Murphy Family Submission

DA2020/1167

DA Property Address: 28 Fisher Road and 9 Francis Street Dee Why

1.1a - Current Solar Access Elevation Obstacle

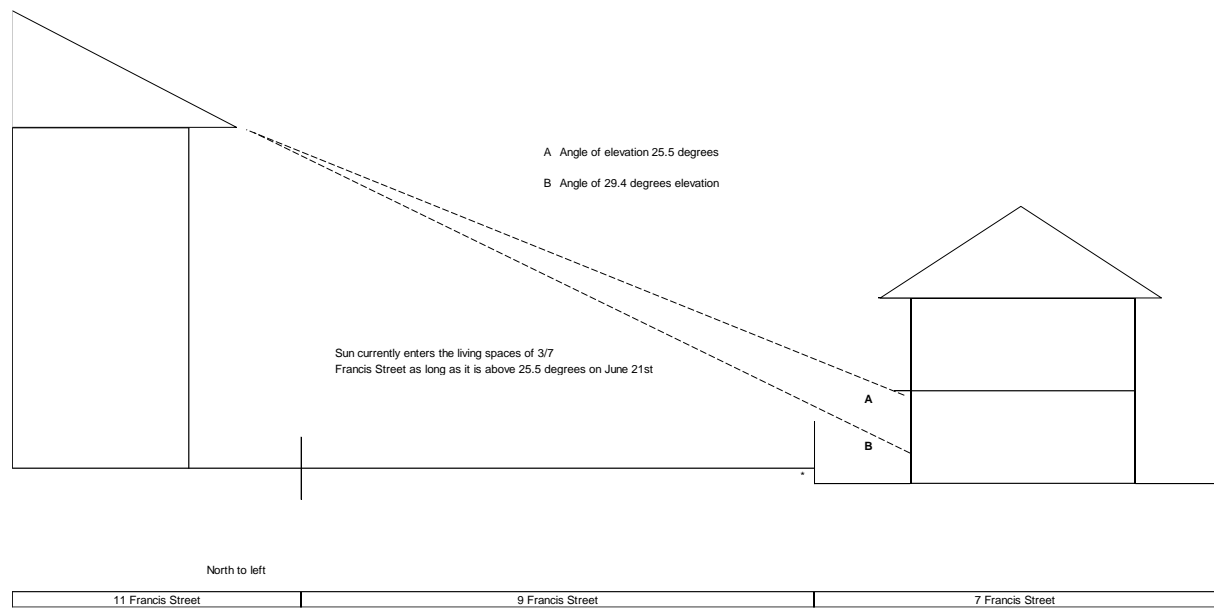
- Above image illustrates that sun elevated at or above 25.5 degrees currently enters the living areas of 3/7 Francis Street

- Above image confirms 25.5 degrees elevation produces direct sunlight into the living space of 3/7 Francis Street

1.1b - Current Solar Access Elevation & Azimuth Chart

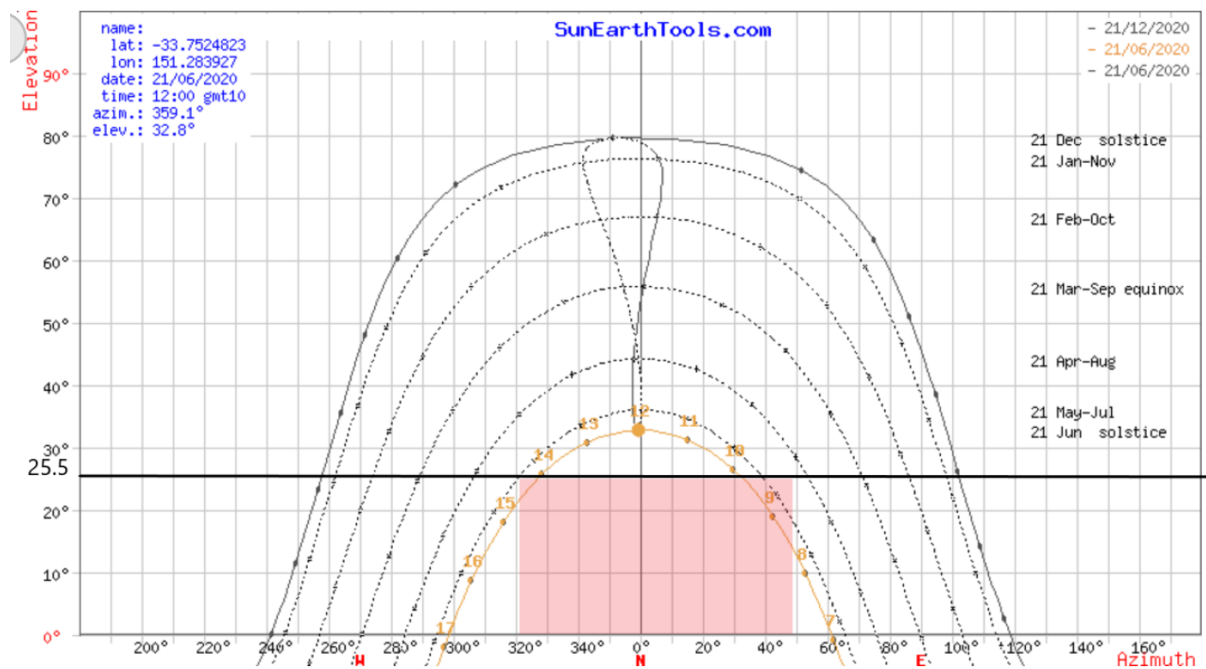
- The above diagram illustrates the entire year of solar access via the elevation and azimuth that the sun passes through on the 21st of each month, with hours indicated as nodes on the lines.
- Overlaid on the above diagram are
 - The current built environment and its relative angles to the living spaces of 3/7 Francis Street shaded Red
- The above diagram illustrates that on June 21st, the sun is elevated above 25.5 degrees from just before 10am and remains there until after 2pm. This confirms we currently receive over 4 hours of direct sunlight into our living spaces on June 21st

Appendix 1.2a – Proposed Solar Access Elevation & Azimuth Chart

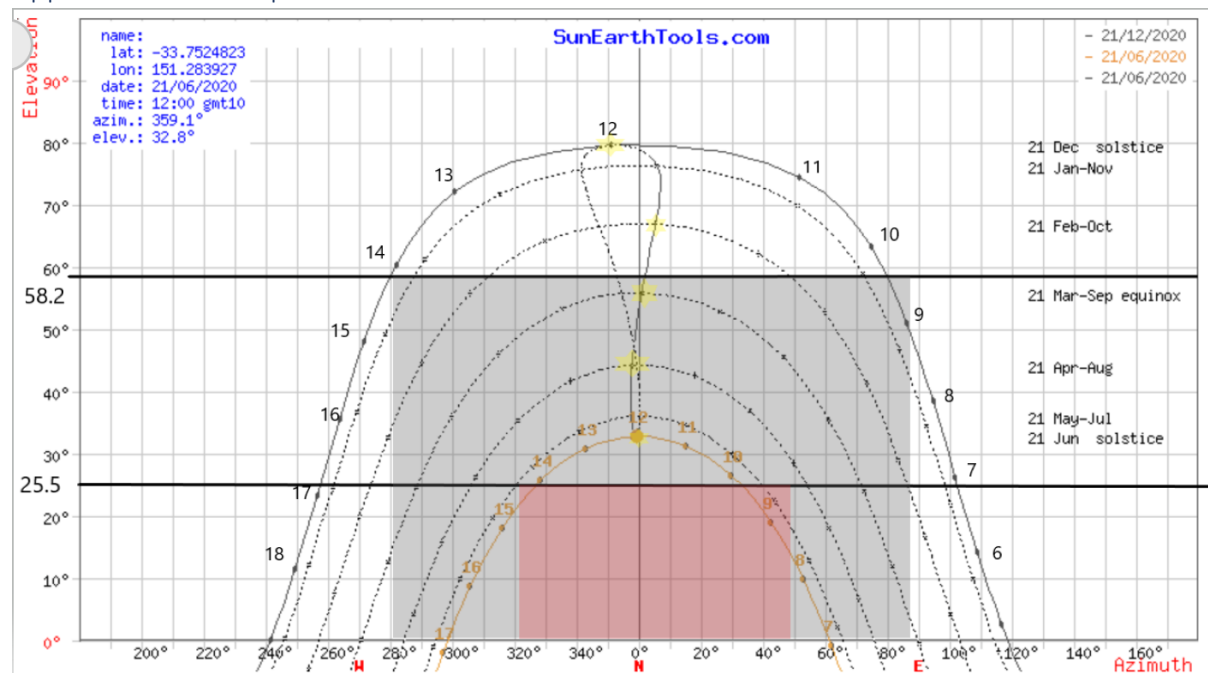
- The above diagram illustrates the entire year of solar access via the elevation and azimuth that the sun passes through on the 21st of each month, with hours indicated as nodes on the lines. Midday is highlighted in yellow for each month of the year.
- Overlaid on the above diagram are
 - The current built environment and its relative angles to the living spaces of 3/7 Francis Street shaded Red
 - The proposed development and its relative angles to the living spaces of 3/7 Francis Street shaded grey
- The above diagram depicts the proposed development will take away direct sunlight from the living spaces of 3/7 Francis Street. Not only will this occur on June 21st, but also for many months of the year. Under the proposal, the only months where 3/7 Francis Street would receive 3 hours of sunlight into living spaces during 9am and 3pm would be November, December & January.

Appendix 1.2b – Proposed Solar Elevation Obstacle

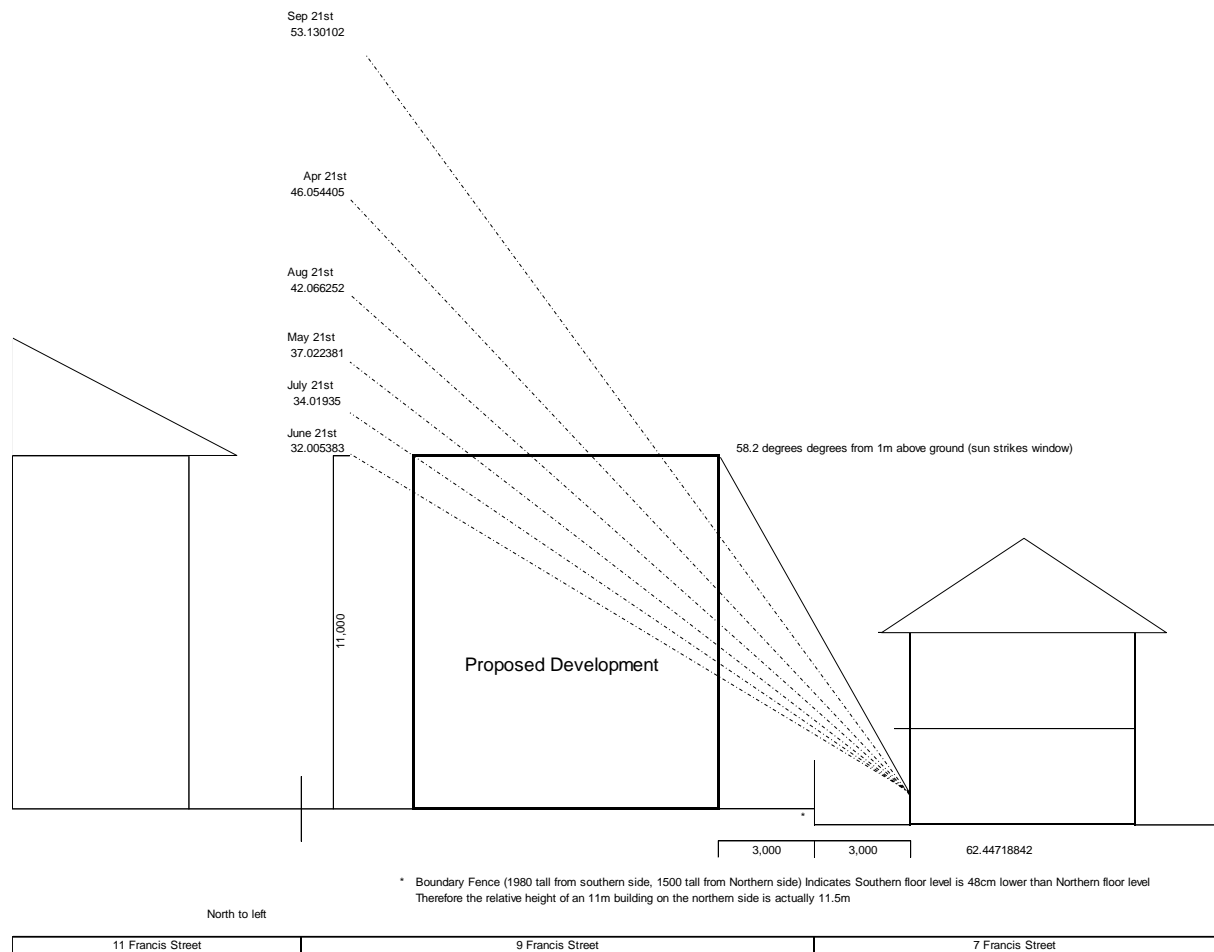
- The dotted lines refer to the peak elevation of the sun on the 21st of the listed months as measured from 1m above floor level where sun enters the living spaces at 7 Francis Street
- During the listed months, the proposed development blocks the direct solar access entirely for the middle residents of 7 Francis Street.**
- The diagram also illustrates that current solar access is uninhibited.

June 21st

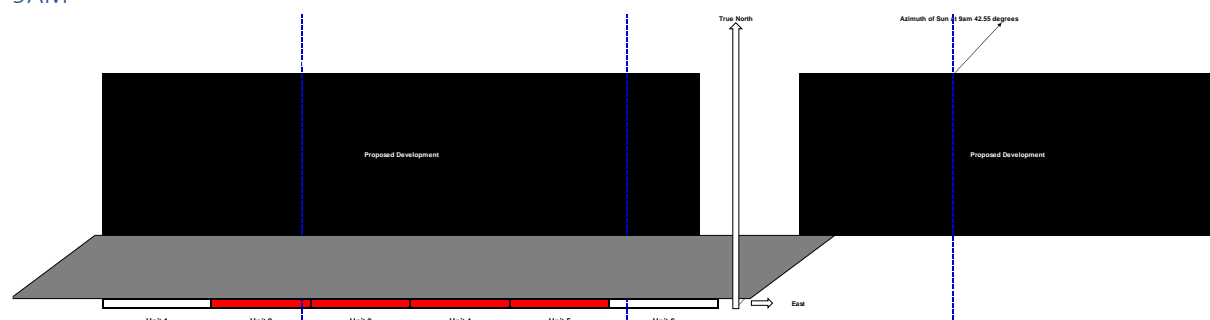
- a) **Under the proposal, 4 of the 6 apartments (those in Red) at 7 Francis Street will receive no sunlight (Yellow) to their living spaces, windows, private open spaces or thermal mass.**

PROPOSED SUN SHADOW PLANS JUNE 21

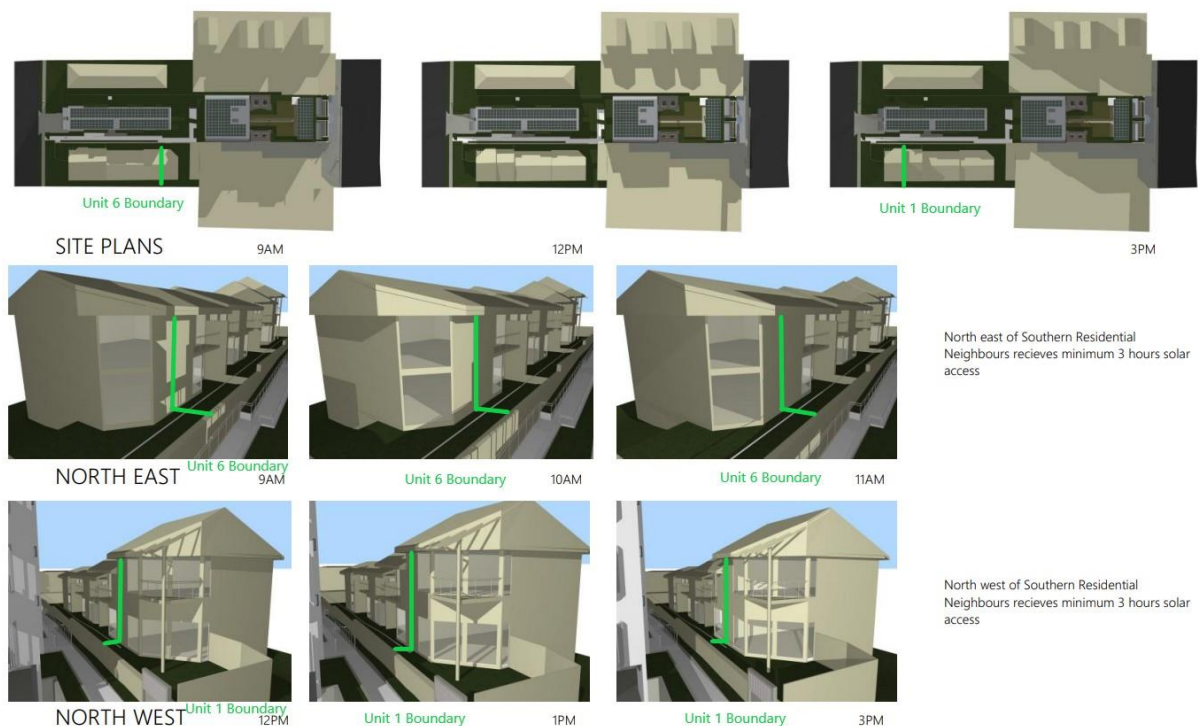
Proposed inaccuracy in above diagram provided by the applicant

- The diagram shows direct sunlight striking low elevations of the North East corner of 7 Francis Street at 9am and 10am.
 - We believe this is incorrect. The surrounding built environment in the azimuth of the sun between 9 and 10am from the North East of 7 Francis Street has an elevation (from 1m above ground level) of 18 degrees between roof peaks and 25 degrees at roof peaks on the southern side. For the sun to hit 7 Francis Street as indicated by the Solar study at 9am is impossible, as it does not reach 18 degrees elevation until 9:52am.
